Solent Road, Havant PO9 1JH
Proposed Development - Rights of Light

I refer to your recent instructions for the provision of preliminary Rights of Light advice in relation to your proposed development at Solent Road, Havant PO9 1JH and, specifically, the impact of the development on, 1-6 Manor Court, 11 Brockhampton Road, Havant PO9 1PH.

Diagram A:

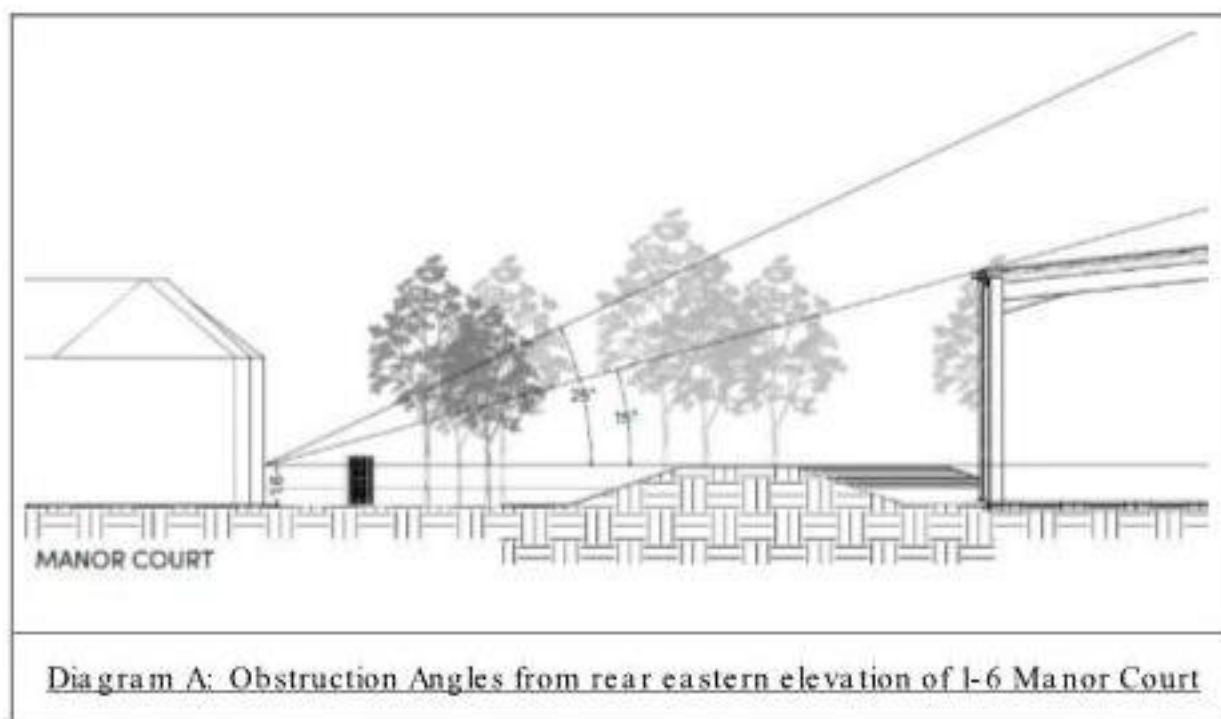
In this instance and as depicted in Diagram A below the angle of obstruction from the centre point of the ground floor windows is some 15-degrees, well below the 25-degree line permitted by the test.

The subject property will therefore continue to enjoy excellent access to natural daylight in full accordance with the BRE guidance and no further analysis is recommended.

Diagram B:

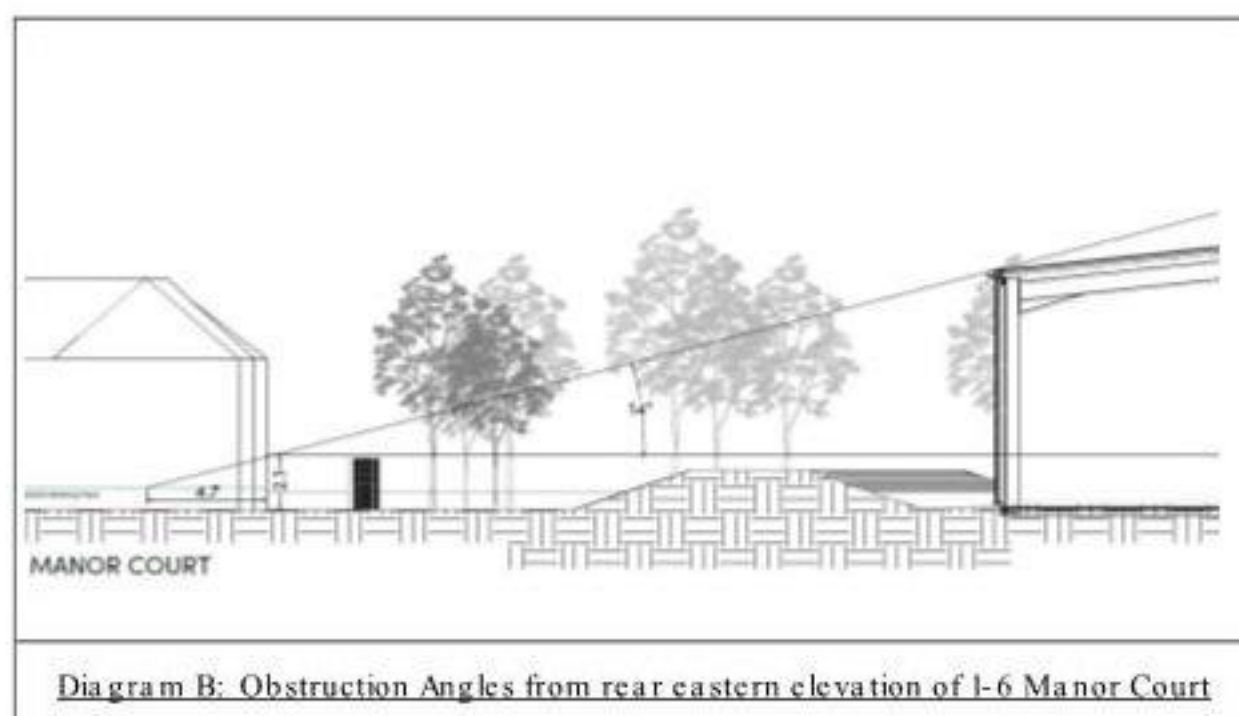
Diagram B indicates that direct sky visibility will be available within the ground floor rooms to the neighbouring property at a depth of up to 4.7m at working plane height.

This in turn indicates that a single aspect room within the neighbouring property with a plan depth of some 9m would not be affected to an actionable level by the proposed development.

Given the residential nature of the neighbouring property it is anticipated that it is likely to have a room depth of circa 4m, considerably less than the safe depth of 9m determined above.

The proposed development is therefore not considered to pose a risk of leading to an actionable Right of Light infringement at this property.
